STM AMPLIFIER CIRCUIT DIAGRAM

STM-0 AMPLIFIER CIRCUIT DIAGRAM

ST/M-0 SERIES

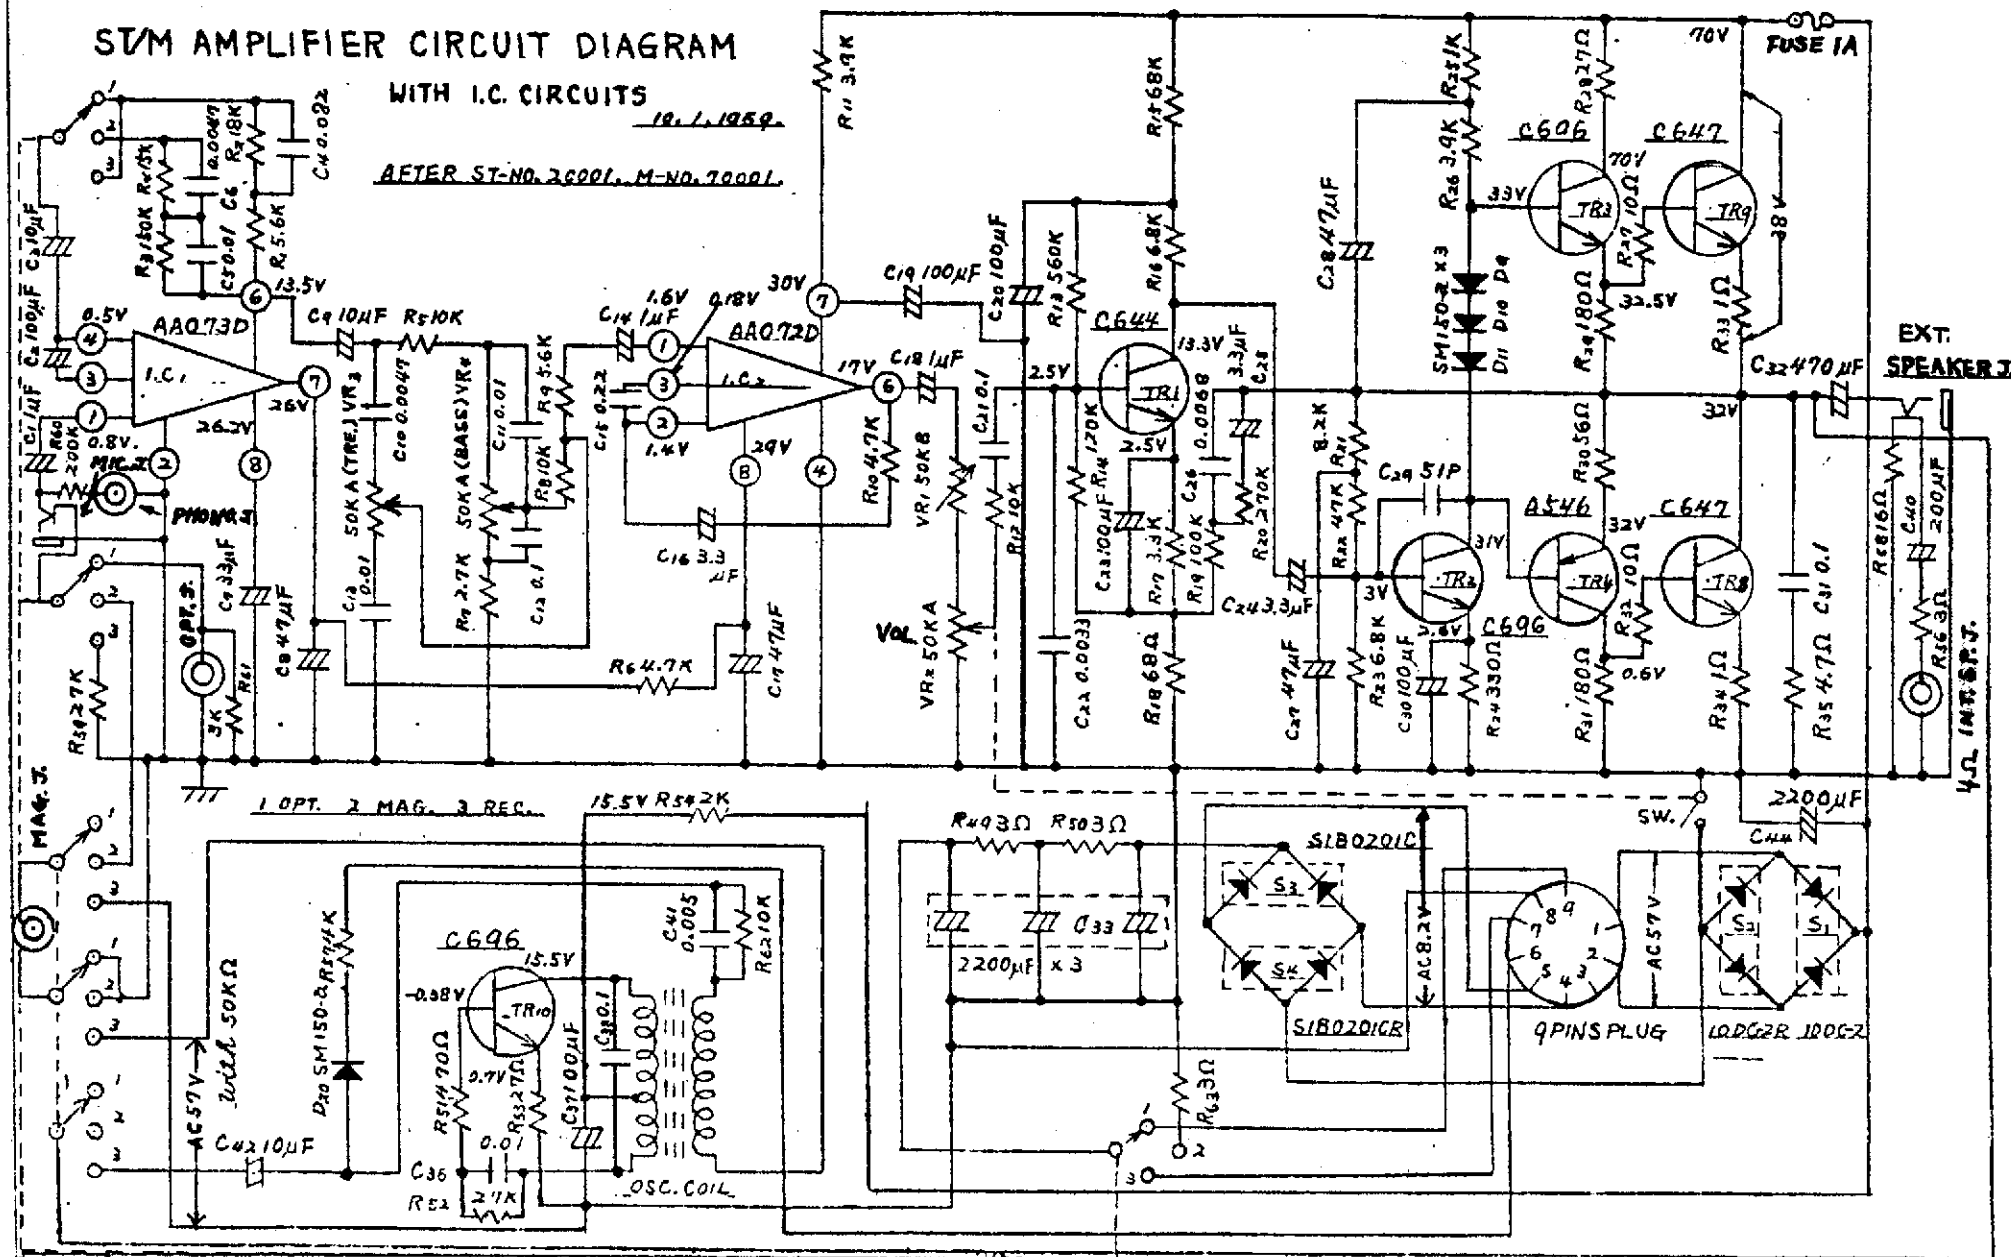
AFTER ST-NO. 26001, M-NO. 70001.

REVIS~~E~~
11.10.1971. MAG. Ru 15KΩ → 4.7K change. C20.004T ground.

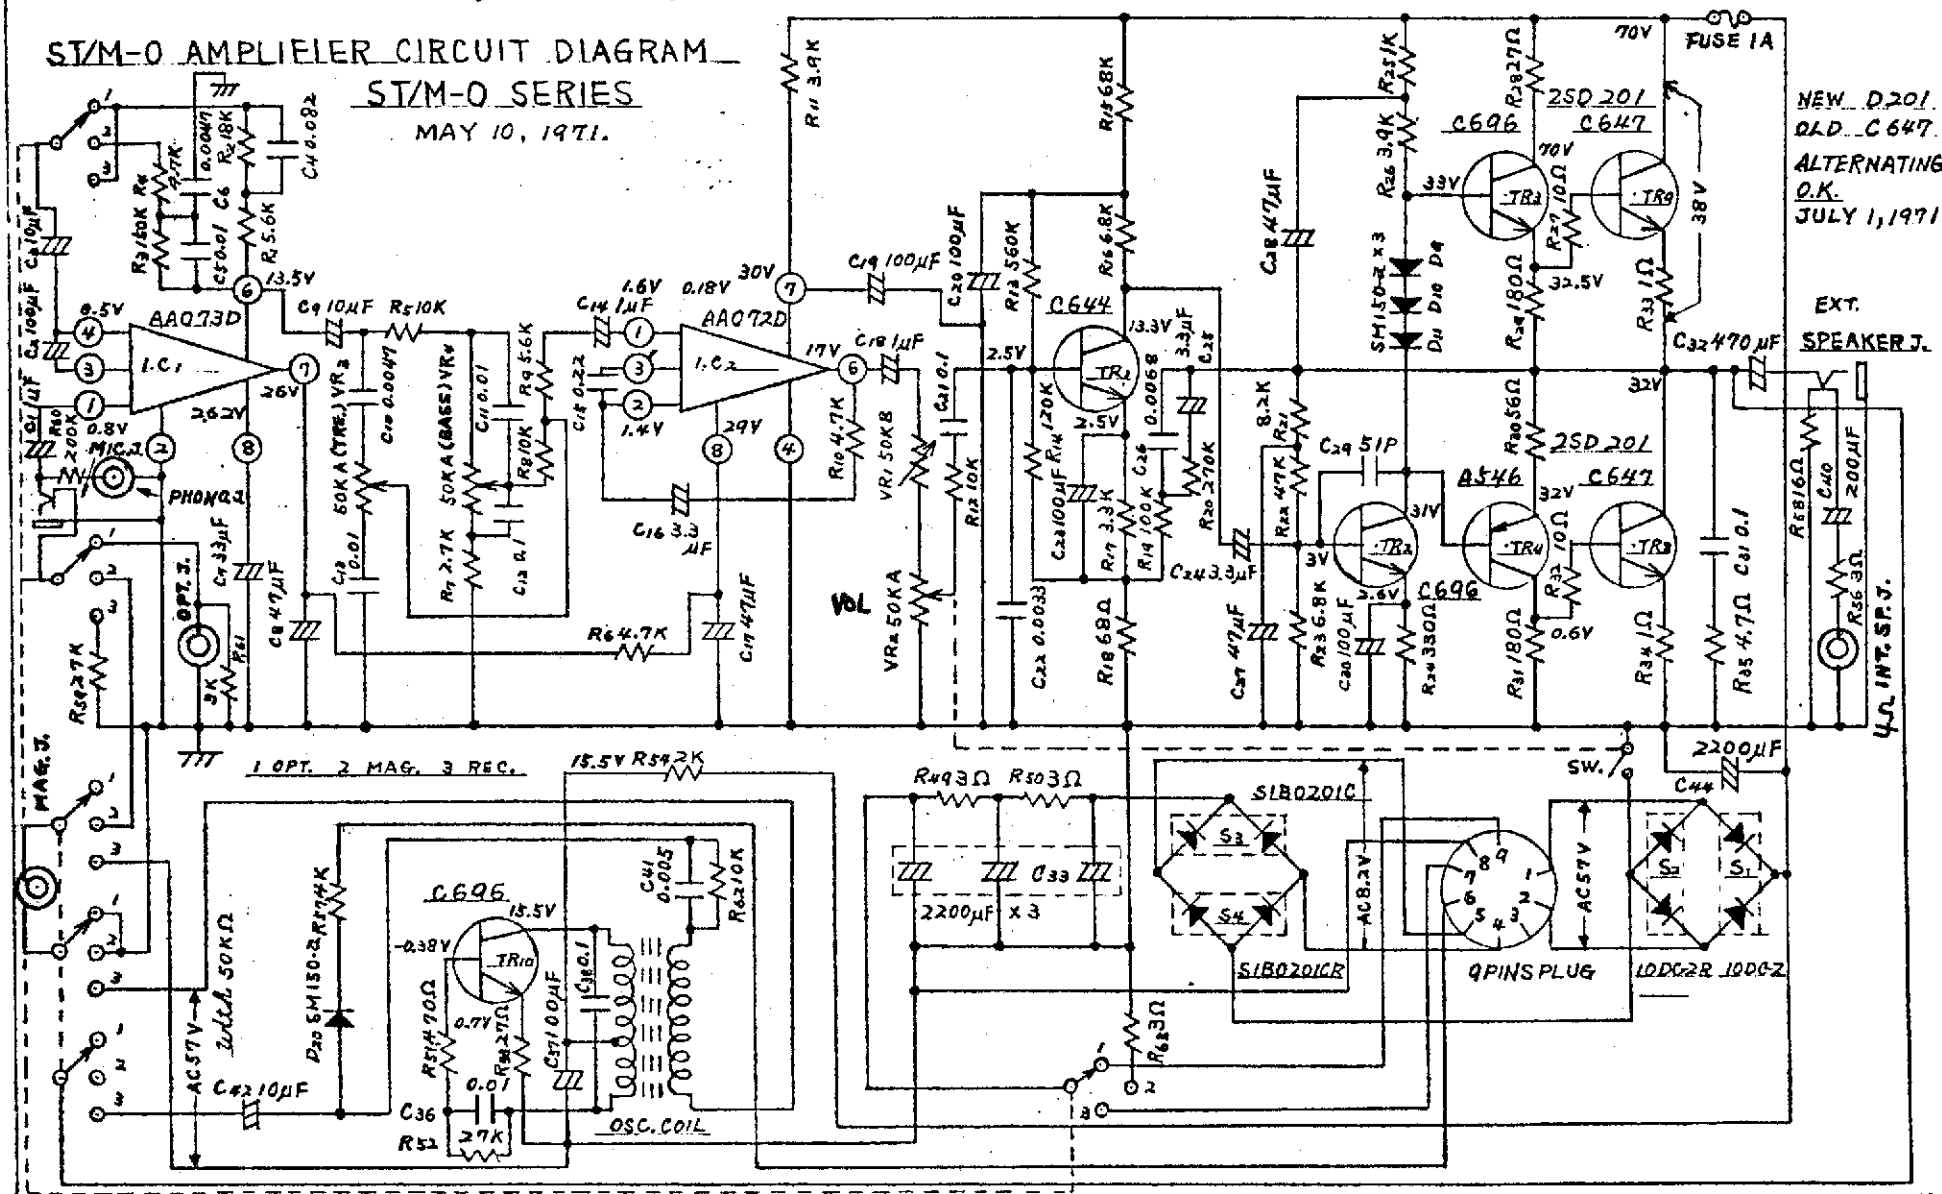
NEW D201
OLD C647
ALTERNATING
O.K.
JULY 1, 1971
